Planning Stage Structural Report

150 Day Street

Prepared for UOL / 20th March 2025

Issue: Revision 2

DRAWING TITLE
BASEMENT 02 PLAN

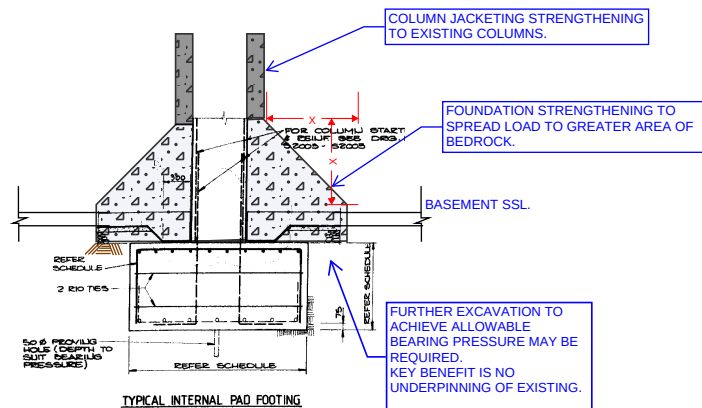
APPROXIMATE LOCATION OF GEOTECHNICAL
FAULT ZONE THROUGH SITE, WITH LOWER
ALLOWABLE BEARING CAPACITY

APPROXIMATE LOCATION OF CROSS
CITY TUNNEL.
DEPTH AND LOCATION TO BE
CONFIRMED, ALLOW FOR
CONSULTATION WITH STAKEHOLDERS
TO DISCUSS IMPLICATIONS OF
ADDITIONAL STOREYS ON FOUNDATION
FORCES.

INTERNAL FOUNDATION STRENGTHENING STRATEGY

ALLOW FOR EXCAVATION AND NEW FOOTING AT EACH LOCATION SHOWN DOTTED.
AT THESE LOCATIONS, EXISTING FOOTING WILL LIKELY REQUIRE EXTENSION TO
PROVIDE BASE TO STRENGTHENED PERIMETER COLUMN.

FOOTING TO BE ENTIRELY BELOW EXISTING BASEMENT SSL TO NOT INTERRUPT
EXISTING PLENUM AND DRAINAGE.
SEE COLUMN STRENGTHENING DETAILS IN THIS REVIEW SET FOR MORE
INFORMATION.
INTENTION AT THESE AREAS IS THAT BACK-PROPPING, JACKING AND
UNDERPINNING BE MINIMISED AND ELIMINATED IF POSSIBLE.

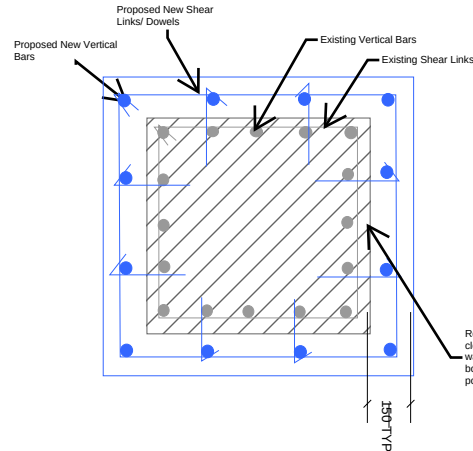
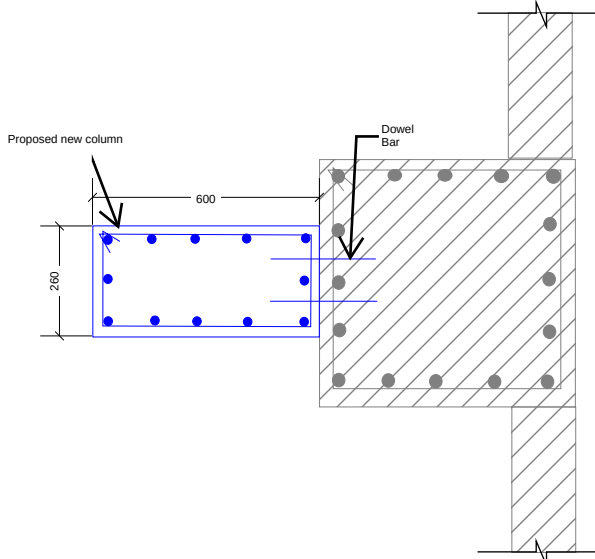
EXISTING LIFT CORE TO BE STRENGTHENED
BY WRAPPING WITH 350 THICK CONCRETE.
FOOTING STRENGTHENING VIA
UNDERPINNING SHOULD BE ALLOWED FOR AT
EXISTING LIFT LOCATION.

ALLOW FOR INTERNAL RETURN COLUMN ON INSIDE FACE. NEW LOADS FROM
ADDITIONAL STOREYS TO LOAD DIRECTLY INTO THESE EXTENSIONS.
PLAN GEOMETRY OF STRENGTHENED SECTION MAY BE MODIFIED, AT TYPICAL
HOTEL FLOOR INTENTION IS FOR COLUMN TO FIT WITHIN HOTEL WALL.

DRAWING TITLE
LEVEL 01 PLAN

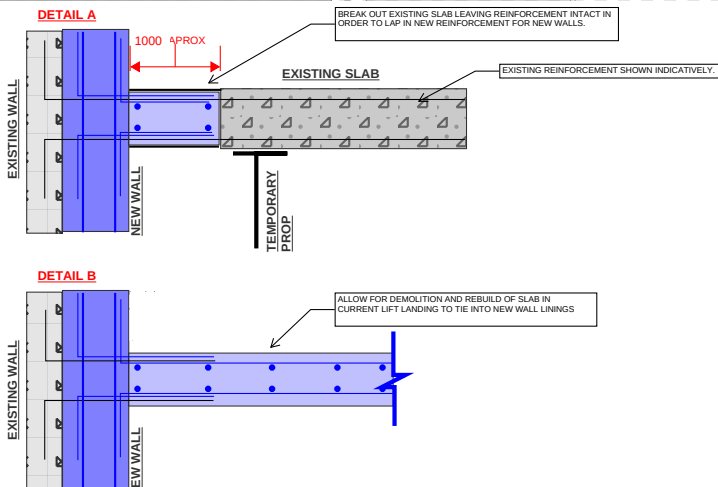
EXISTING STRUCTURAL SYSTEM:
CONVENTIONALLY REINFORCED FLAT SLAB WITH DROP PANELS
EXISTING FRL AT LEAST 90/90/90
EXISTING LIVE LOAD CAPACITY LIVE LOAD- 5kPa, SUPERIMPOSED
DEAD LOAD- 2kPa (PARTITIONS)

PERIMETER COLUMN STRENGTHENING.
SEE NOTE ON BASEMENT PLANS OF THIS SET.

NOTE REGARDING BUILDING JOINT:
THERE IS AN EXISTING BUILDING JOINT AT GRID 8 WHICH STRUCTURALLY SEPARATES THE STRUCTURE TO THE NORTH AND SOUTH OF THIS LINE FROM THE BASE TO THE TOP OF THE EXISTING STRUCTURE.
STEEL PLATES WILL BE USED TO TIE TOGETHER THE STRUCTURE ACROSS THIS JOINT AT ALL FLOORS SO THAT THE BUILDING BEHAVES ROBUSTLY AS A SINGLE STRUCTURAL ELEMENT.

NOTE: FORMING NEW SET-DOWN OR REBATES IN EXISTING SLAB WILL NOT BE POSSIBLE DUE TO EXISTING REINFORCEMENT DEPTHS.
TILING ZONE REQUIREMENTS AND THRESHOLDS MUST BE CAREFULLY COORDINATED TO ENSURE THAT WEIGHTS REMAIN WITHIN STRUCTURAL LIMITATIONS AND STEPS OR RAMPS ARE ARCHITECTURALLY ACCEPTABLE.

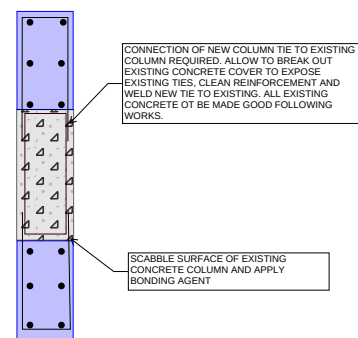
EXISTING FIRE STAIR AND ATRIUM VOID IN FILLED WITH STRUCTURAL STEEL BEAMS AND BONDEK IN ARRANGEMENT SHOWN.

GENERAL SOLUTION TO INFILL EXISTING
STAIR VOIDS WITH BONDEK AND
STRUCTURAL STEEL FRAMING.

SEE NOTE ON LEVEL 2 PLAN REGARDING
WHAT WOULD BE REQUIRED IN TERMS
OF BUILDING A NEW TRANSFER BEAM
TO REMOVE COLUMN AT L2.

1 L04 PLAN
RS_020 1:200

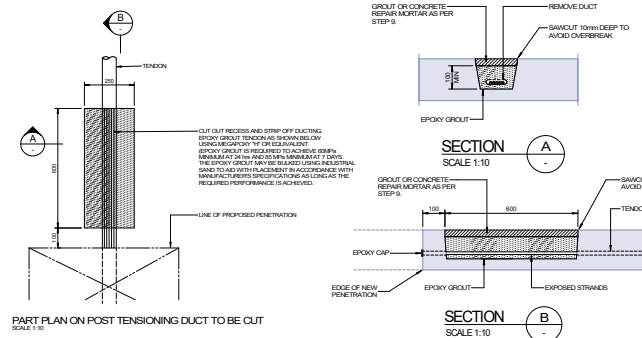
NOTE ON REQUIREMENTS FOR TRUNCATING EXISTING POST-TENSIONING.

FOR NEW LIFT AND STAIR SOUTH OF GRID E8 IN PARTICULAR.

TRUNCATION OF EXISTING POST-TENSIONING WILL BE REQUIRED TO FORM NEW OPENING FOR LIFT AND STAIR VOID. DETAILED ANALYSIS REQUIRED AT NEXT DESIGN STAGE IN ORDER TO ASSESS ANY ADDITIONAL STRENGTHENING IN ADJACENT SLAB WHICH MAY BE REQUIRED TO FACILITATE THIS TRUNCATION.

3. For each tendon to be cut, carefully remove a 600 long by 250 wide strip of concrete from above and around the tendon 50mm from the penetration. DO NOT CUT ANY REINFORCEMENT. Strip off the slabs and clean out the existing grout.

7. Cut the slab into manageable chunks and remove them.
8. Remove the platform and props.
9. Fill top portion of strip with 21 sand cement grout or Rendicrete HF for internal applications and Rendicrete HB40 Plus for external applications or areas with no applied finishes. Fill in to be finished with waterproofing concrete surface.

1 L11 PLAN - TRANSFER FLOOR

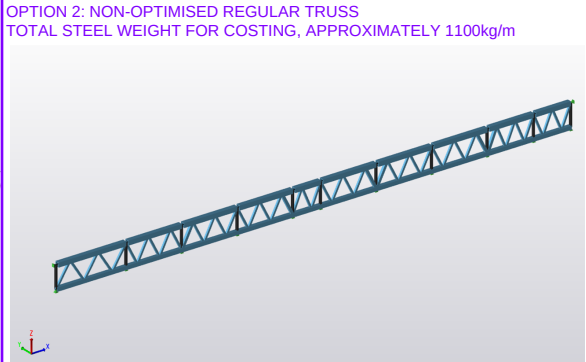
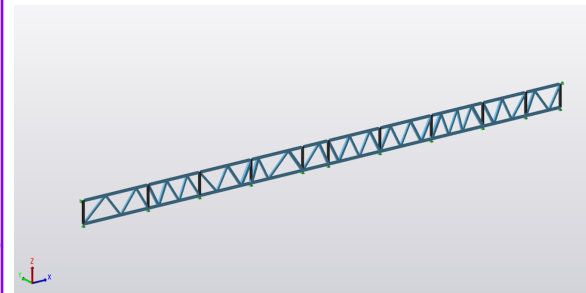
ALLOW FOR STRENGTHENING TO EXISTING L11 STRUCTURE TO FACILITATE CHANGE OF USE. STRENGTHENING MAY BE ACHIEVED BY A GRILLAGE OF BEAMS ABOVE THE EXISTING SLAB (HIDDEN WITHIN AN ACCESS FLOOR) TO SUPPORT THE WEIGHTS OF PLANT, LANDSCAPE AND POOL LOADS.

THIS STRENGTHENING COULD BE INCORPORATED INTO A CONSTRUCTION CRASH DECK WHICH WOULD BE INSTALLED TO ALLOW FOR CONSTRUCTION OF THE ADDITIONAL STOREYS WHILE ACCESS IS MAINTAINED BELOW FOR MODIFICATION AND FIT-OUT WORKS,

NOTE ON HEAVY PLANT EQUIPMENT
HEAVY PLANT WILL REQUIRE STEEL GRILLAGE AT LOW LEVEL FOR STRUCTURAL SUPPORT IN ORDER NOT TO OVERLOAD EXISTING SLAB.
GENERAL INTENTION IS TO PROVE AND ACCESS FLOOR OVER LOW-LEVEL STEEL BEAM GRILLAGES.

STRUCTURAL REVIEW ON EIGHTS OF PLANT, INCLUDING PLINTHS, MUST BE CARRIED OUT TO EXISTING STRUCTURE IS NOT OVERLOADED.
HEAVY PLANT SHOULD BE LOCATED CLOSE TO STRUCTURAL SUPPORTS (COLUMNS) AND LIGHT-WEIGHT PLINTHS SPECIFIED TO MINIMISE STRENGTHENING REQUIREMENTS.

AT BUILDING PERIMETER, COLUMN TRANSFER COULD BE ACHIEVED BY TRUSSES, OR BY DEEP STRUCTURE, POTENTIALLY HIDDEN WITHIN THE DEPTH OF THE PROPOSED PLANTER BEDS.

GENERAL STRUCTURAL SOLUTION TO PROVIDE FULL STOREY STEEL TRUSSES TO TRANSFER COLUMN LOADS AT THIS STOREY.

NOMINALLY, AN IRREGULAR TRUSS WITH OPTIMISED GEOMETRY WILL REQUIRE APPROXIMATELY HALF THE STEEL TONNAGE OF A REGULAR TRUSS.

OPTION 1: OPTIMISED IRREGULAR TRUSS
TOTAL STEEL WEIGHT FOR COSTING, APPROXIMATELY 450kg/m

STRUCTURAL REQUIREMENTS TO SUPPORT WEIGHT OF POOL PLANT MUST BE REVIEWED IN DETAIL WITH INPUT FROM A POOL CONSULTANT.

IN GENERAL, WE WOULD EXPECT THAT A POOL CONSULTANT BE ENGAGED IN ORDER TO PROVIDE SPECIALIST ADVICE REGARDING PLANT, SPATIAL LAYOUTS AND REQUIREMENTS FOR BALANCE TANKS.

NOTE ON DEEP PLANTER ZONE AND INTEGRATED TEMPORARY WORKS DECK AT L11
INCLUSION OF DEEP PLANTER ZONE AT L11 WILL REQUIRE EXTENSIVE STRENGTHENING OF EXISTING STRUCTURE DUE TO INCREASED WEIGHT.

1 L18 PLAN
RS_200 1:200

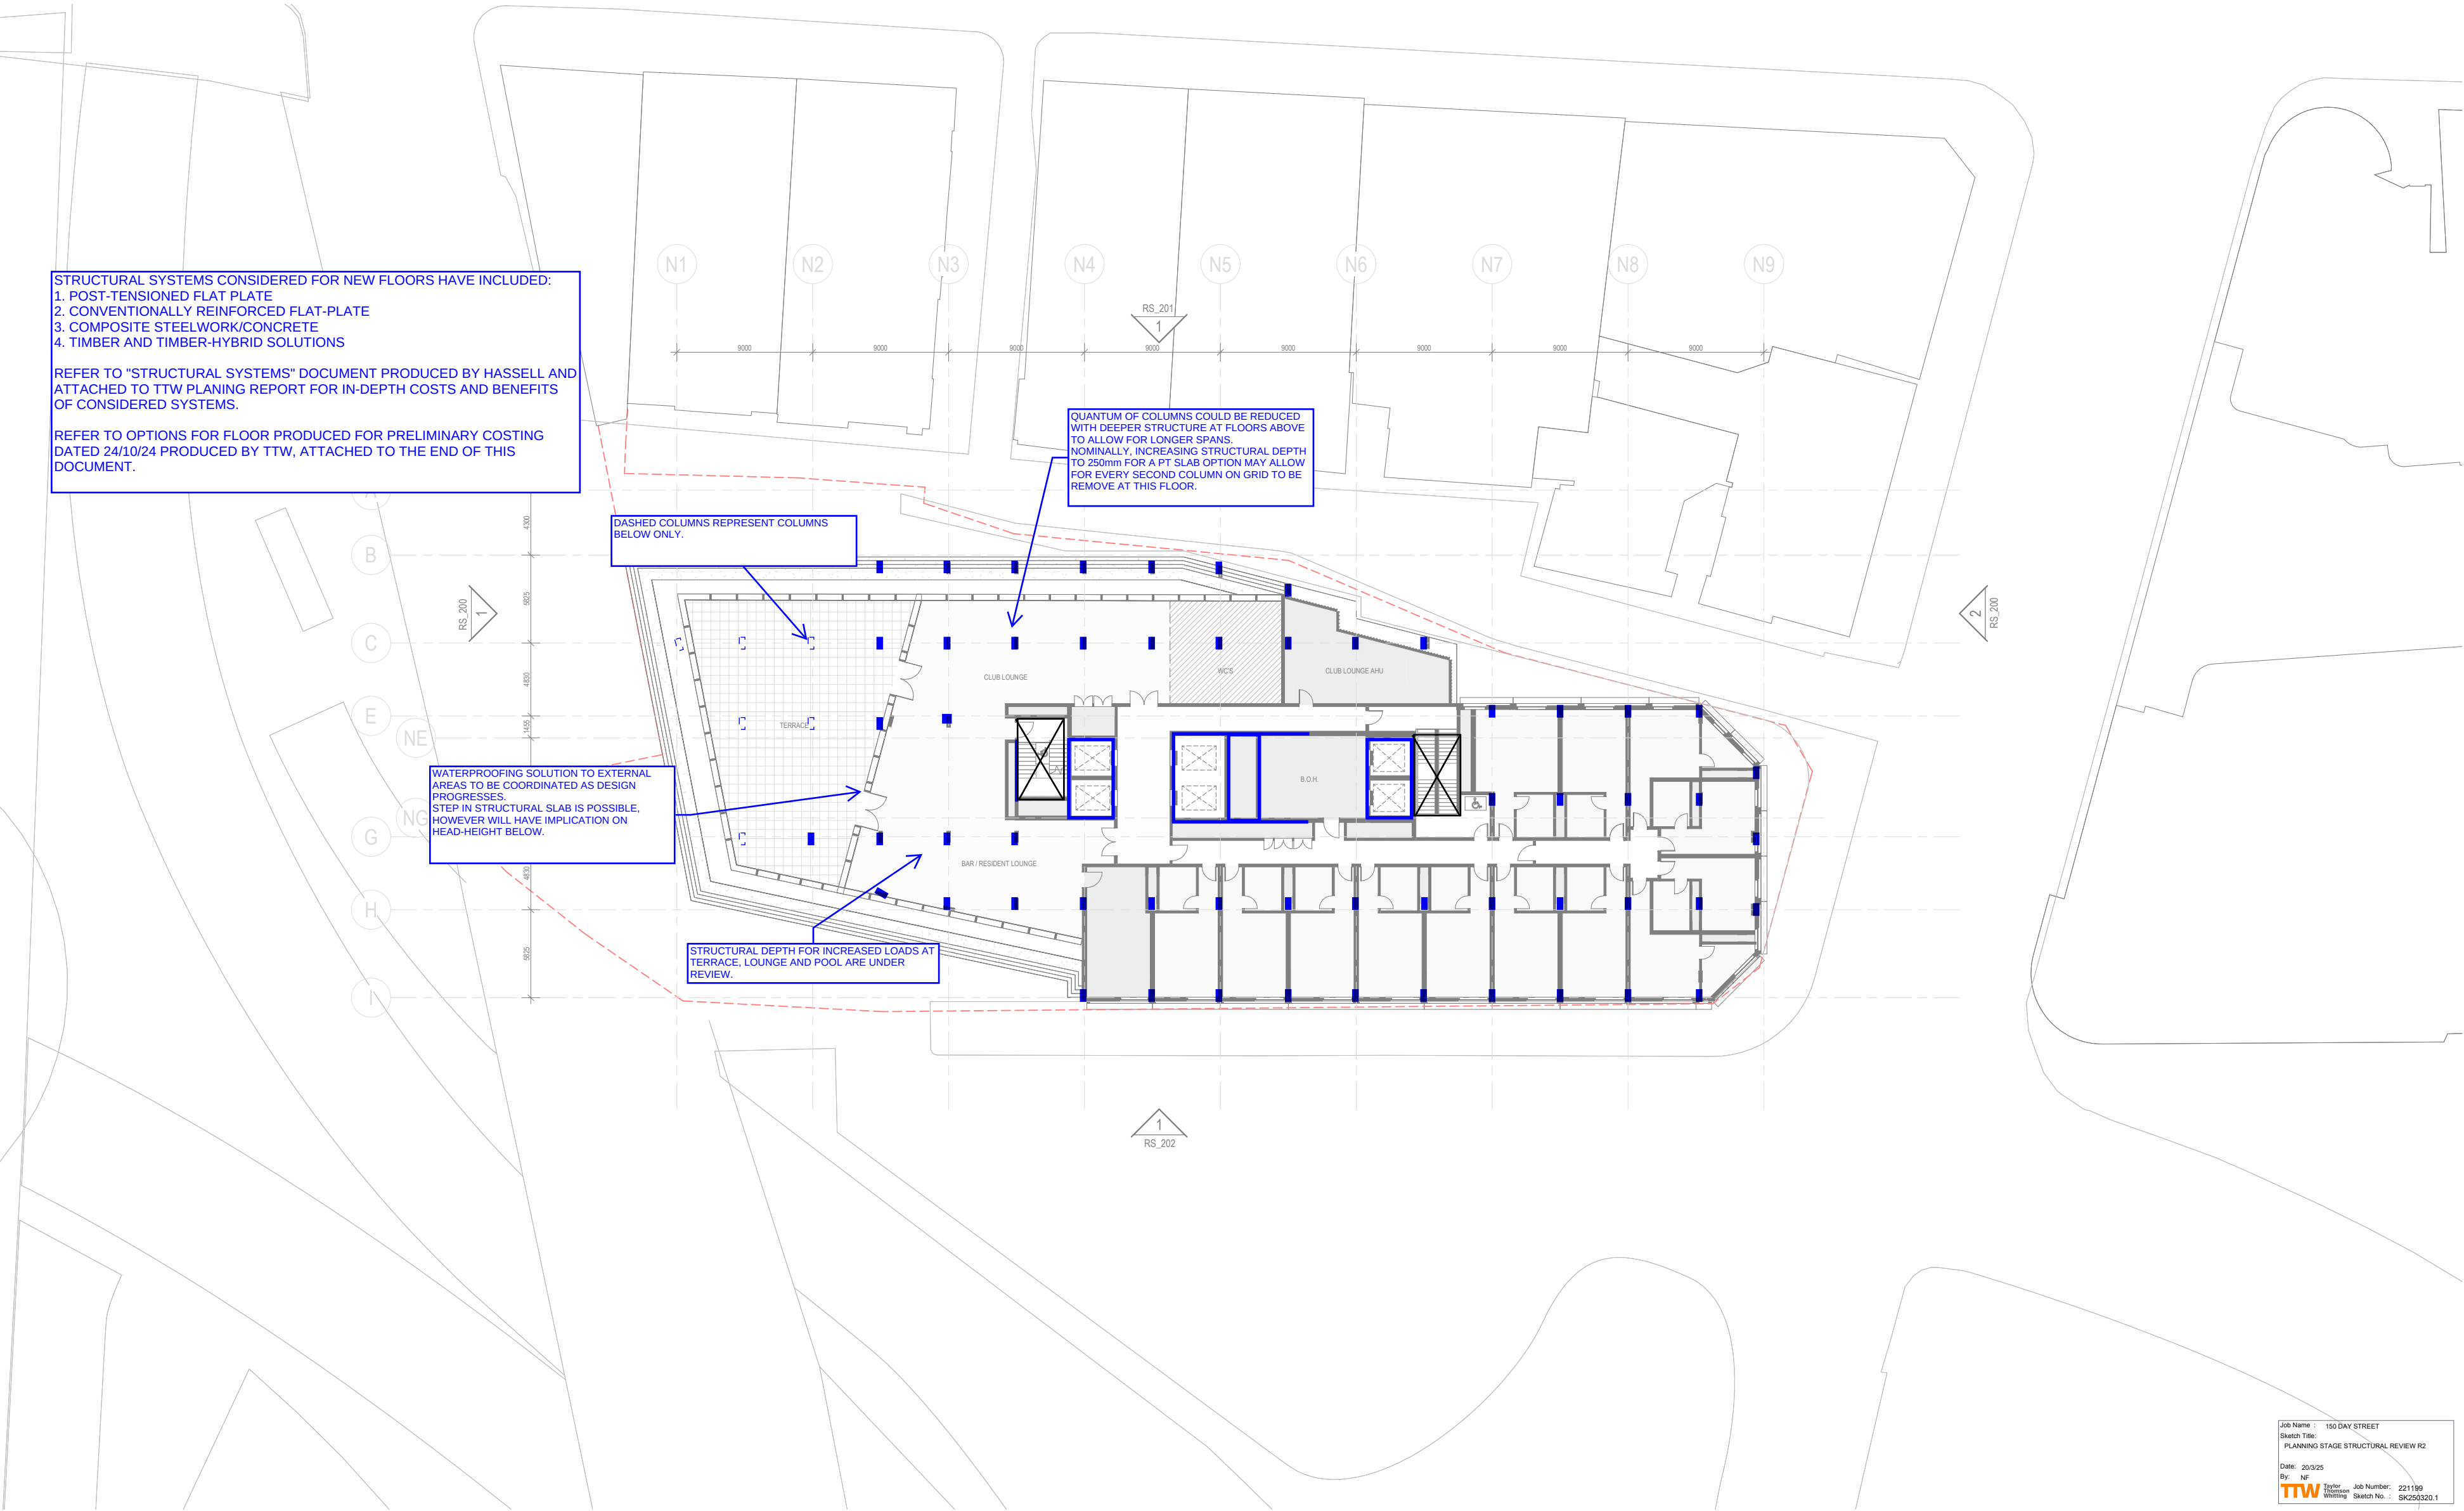
REFER TO OPTIONS FOR FLOOR PRODUCED FOR PRELIMINARY COSTING DATED 24/10/24 PRODUCED BY TTW, ATTACHED TO THE END OF THIS DOCUMENT.

DASHED COLUMNS REPRESENT COLUMNS BELOW ONLY.

QUANTUM OF COLUMNS COULD BE REDUCED WITH DEEPER STRUCTURE AT FLOORS ABOVE TO ALLOW FOR LONGER SPANS. NOMINALLY, INCREASING STRUCTURAL DEPTH TO 250mm FOR A PT SLAB OPTION MAY ALLOW FOR EVERY SECOND COLUMN ON GRID TO BE REMOVE AT THIS FLOOR.

1 L19 PLAN
RS_200 1:200

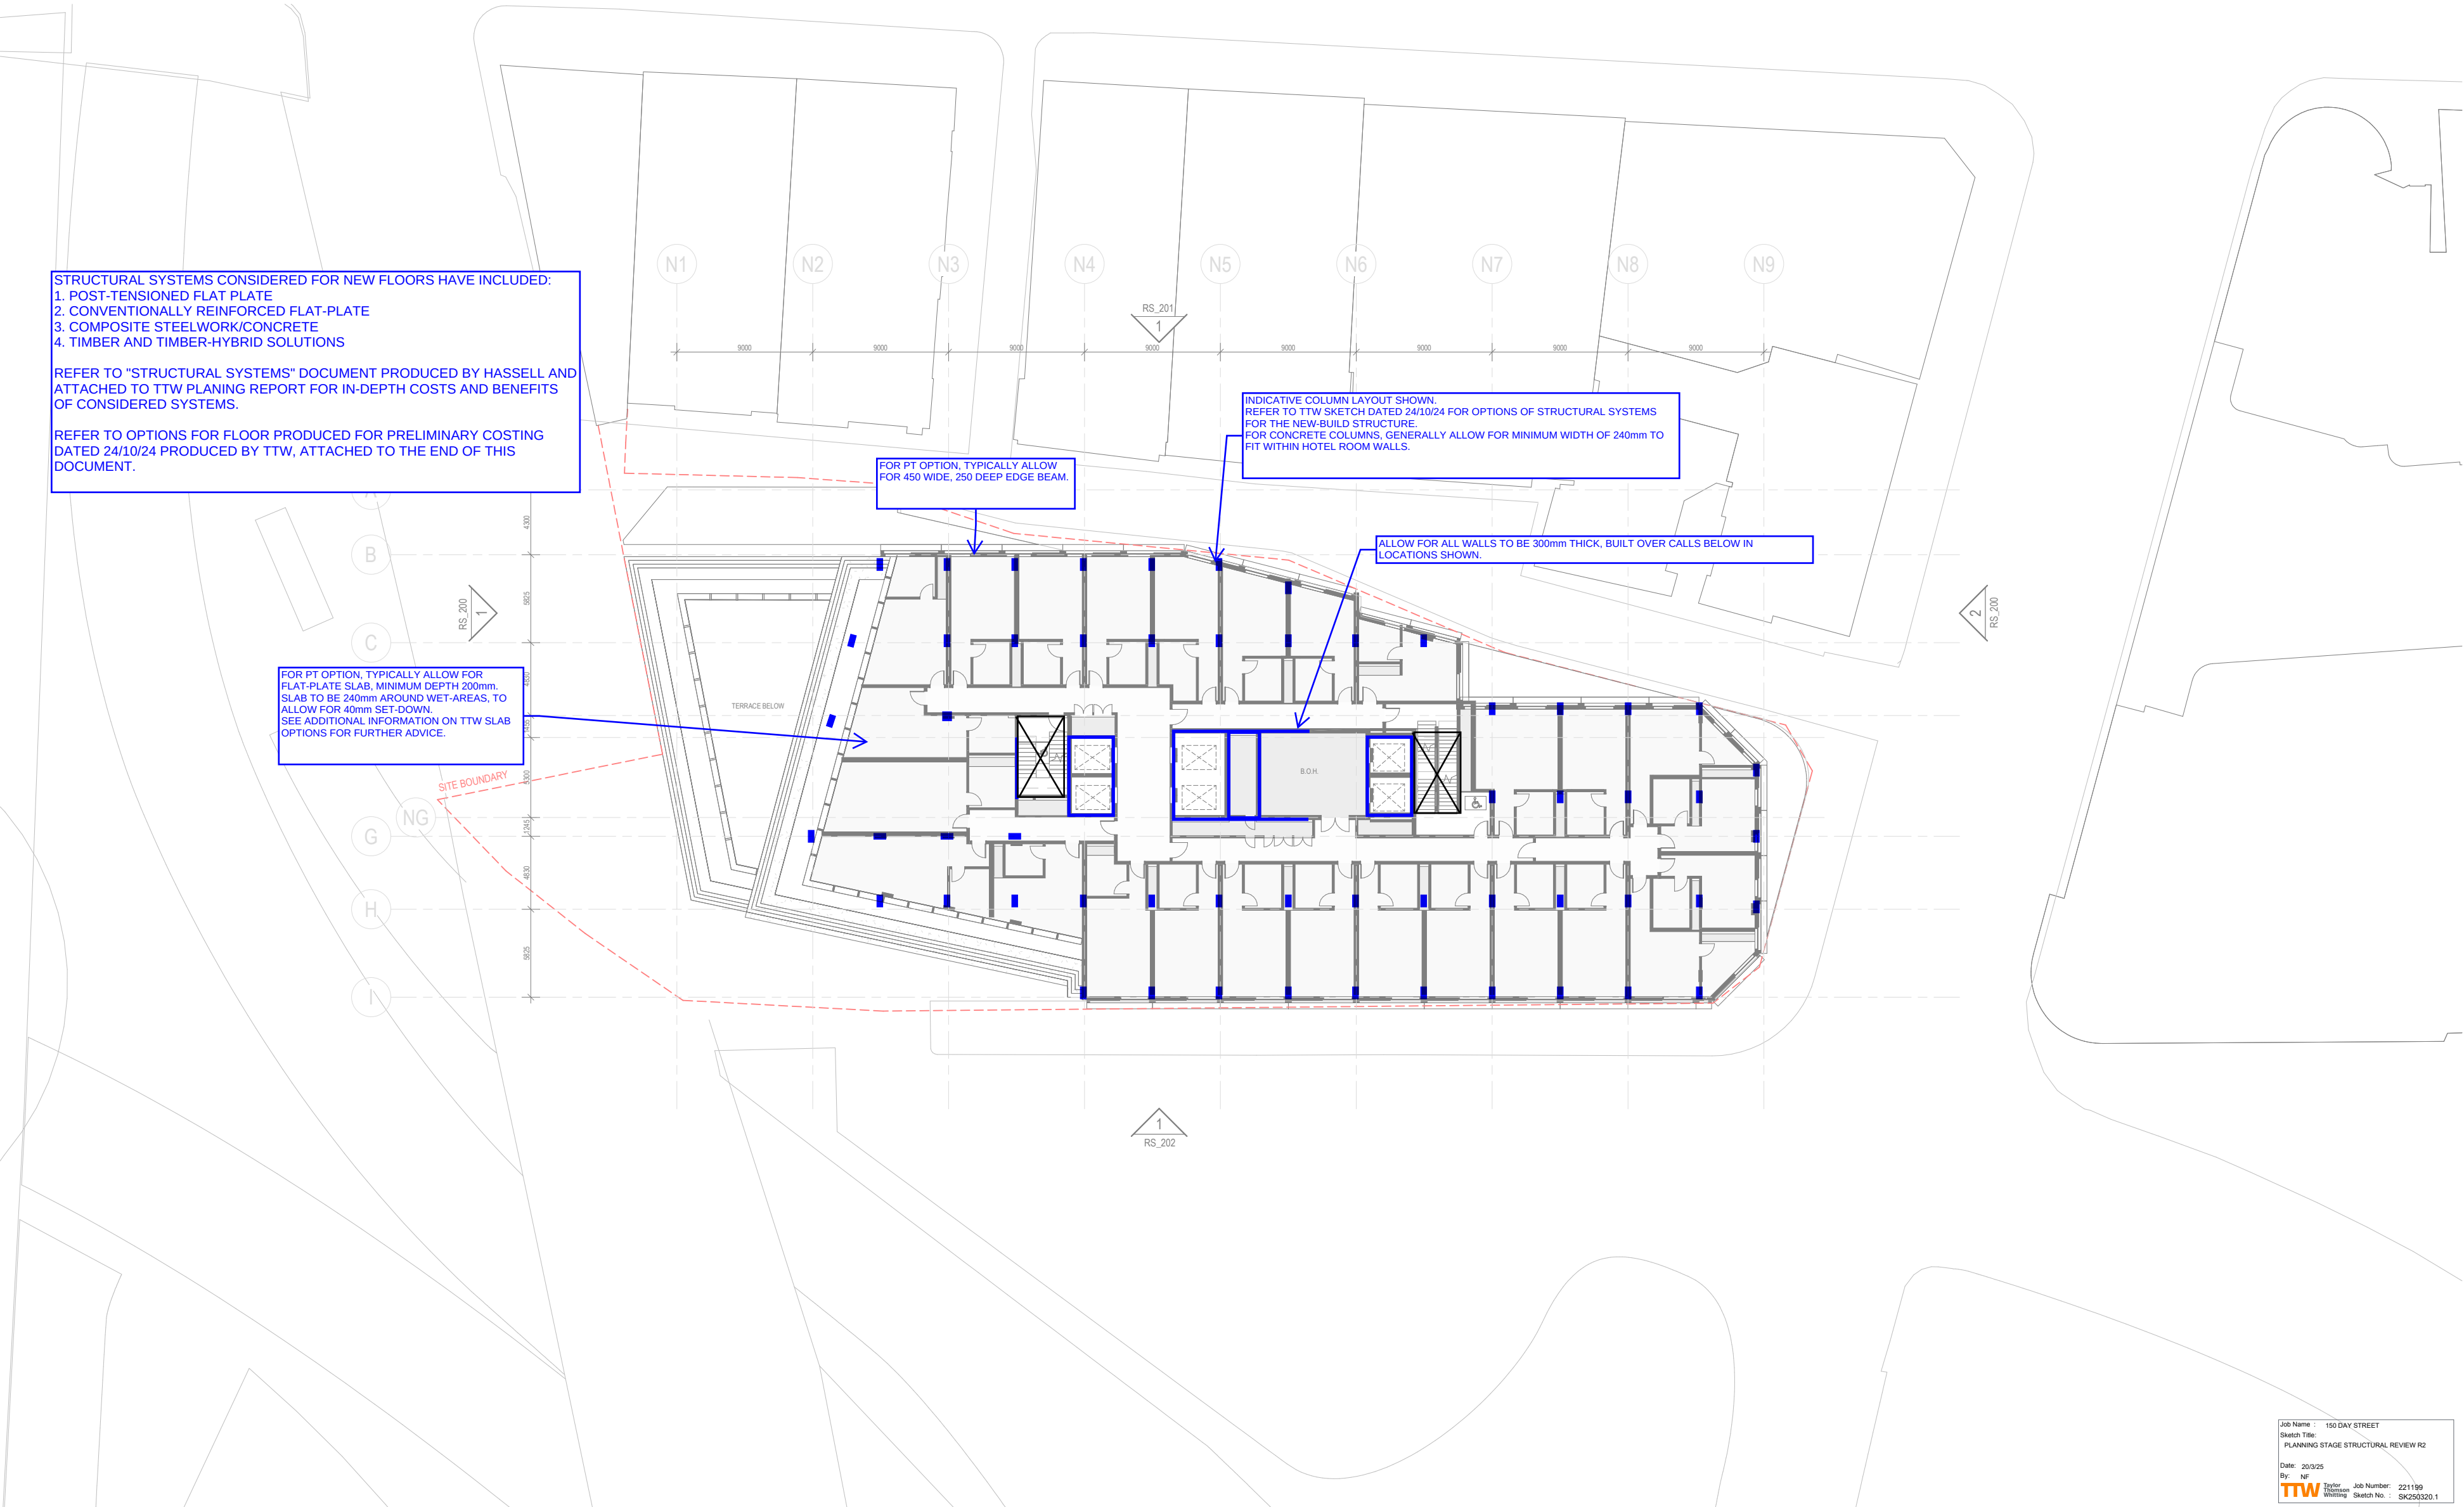
REFER TO OPTIONS FOR FLOOR PRODUCED FOR PRELIMINARY COSTING DATED 24/10/24 PRODUCED BY TTW, ATTACHED TO THE END OF THIS DOCUMENT.

FOR PT OPTION, TYPICALLY ALLOW FOR FLAT-PLATE SLAB, MINIMUM DEPTH 200mm. SLAB TO BE 240mm AROUND WET-AREAS, TO ALLOW FOR 40mm SET-DOWN. SEE ADDITIONAL INFORMATION ON TTW SLAB OPTIONS FOR FURTHER ADVICE.
